**SHEARON HARRIS NUCLEAR POWER PLANT, UNITS 2 AND 3
DOCKET NOS. 52-022 AND 52-023
SUPPLEMENT 2 TO RESPONSE TO REQUEST FOR ADDITIONAL INFORMATION
REGARDING THE ENVIRONMENTAL REVIEW**

**Shearon Harris Nuclear Power Plant Units 2 and 3
Supplement 2 to Response to NRC Request for Additional Information Regarding the
Environmental Review, dated November 13, 2008**

NRC RAI #: 4.3.1-2

NRC RAI #: 9.4-1

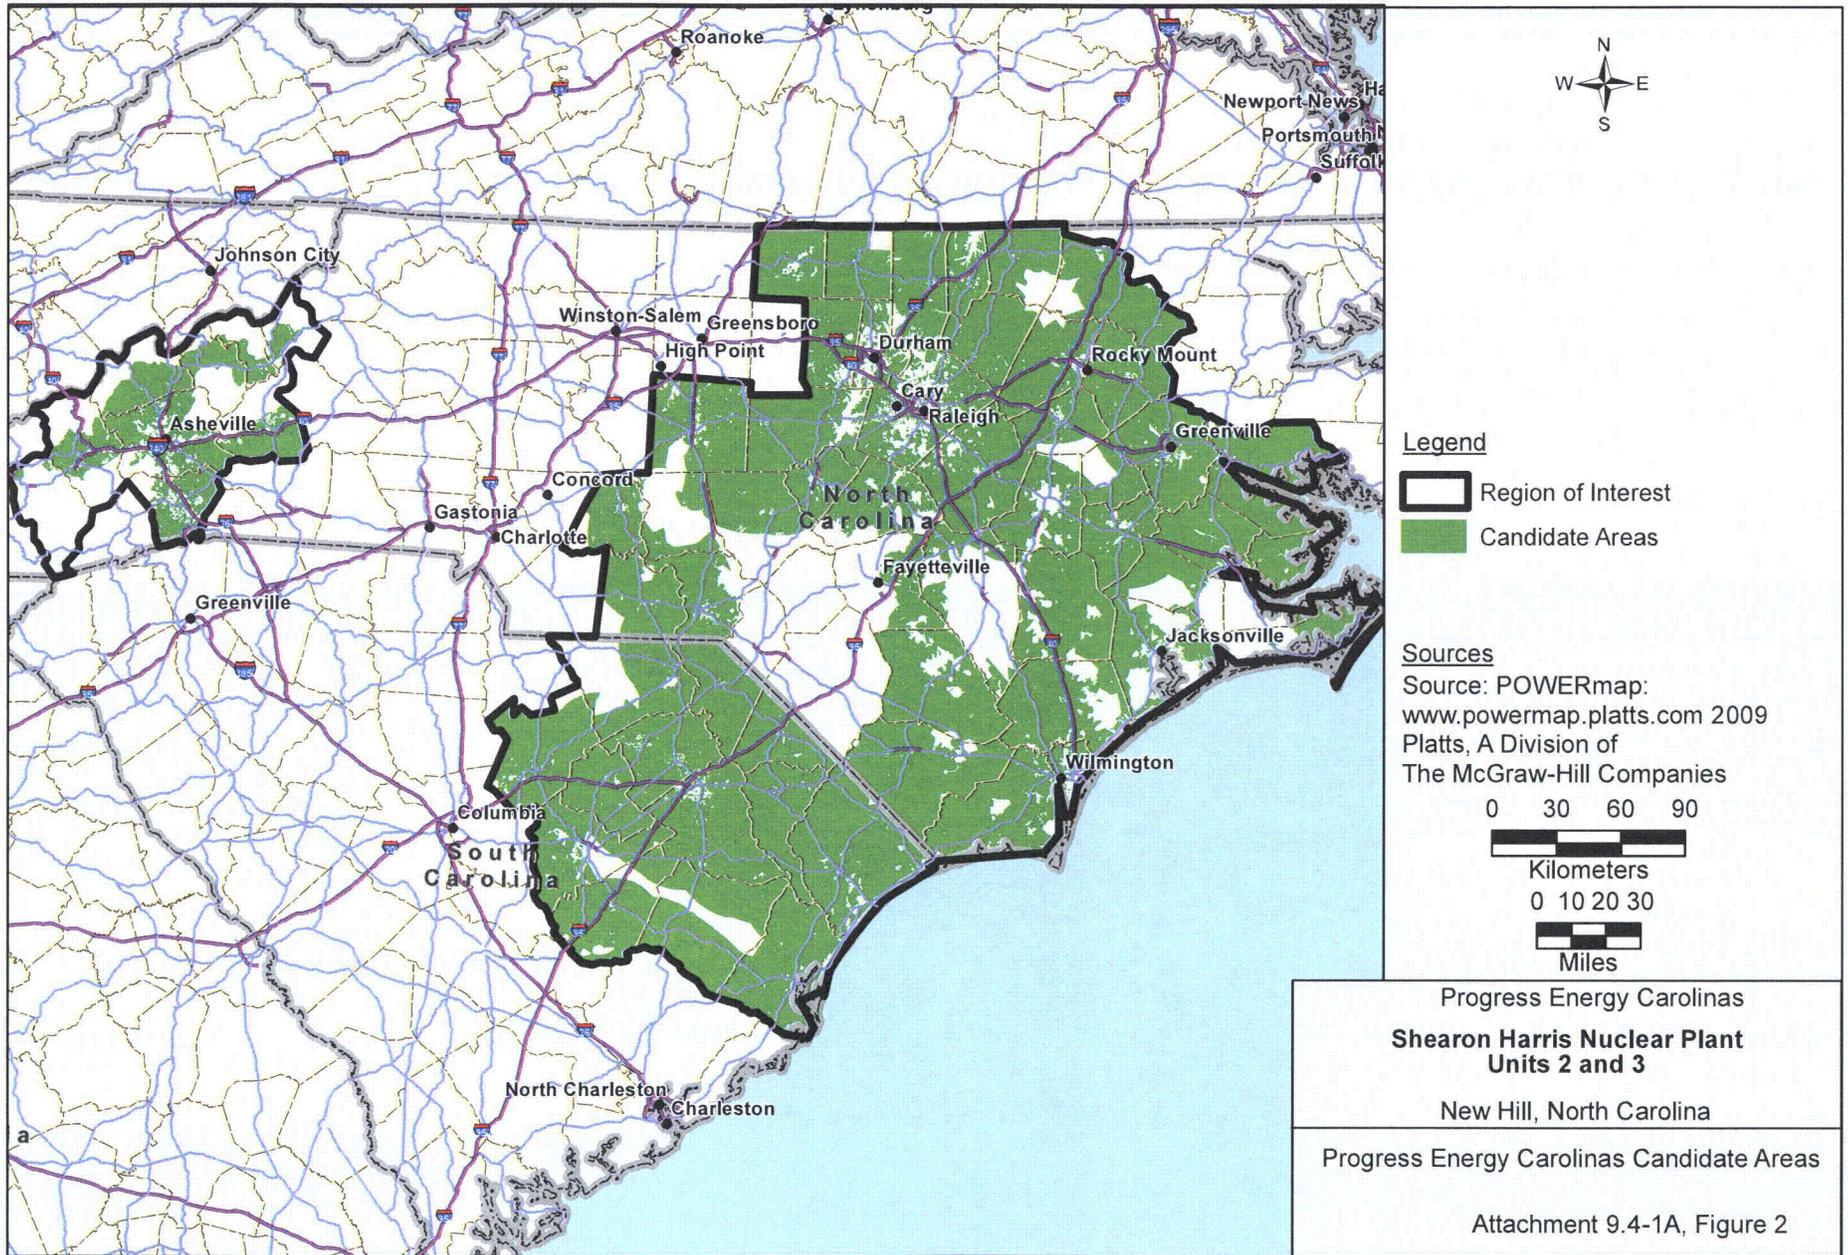
The alternative site selection process should follow a clear and defensible process to determine the final alternative sites, and the proposed site. Analysis performed on the four alternative sites to determine the proposed Harris site is clear and logical; however it is not clear how the region of interest was screened to provide candidate areas, potential sites, and candidate or alternative sites. Please provide a clear analysis of the site screening process from the defined region of interest to the selection of the four alternative sites.

Screening information was obtained from publically accessible geographic information system (GIS) database websites.. Information gathered from the initial screening was used to identify areas not affected by the exclusionary screening criteria. The GIS information was layered to produce a figure that represented the suitable candidate areas for the potential placement of a nuclear power facility (see Figure 2).
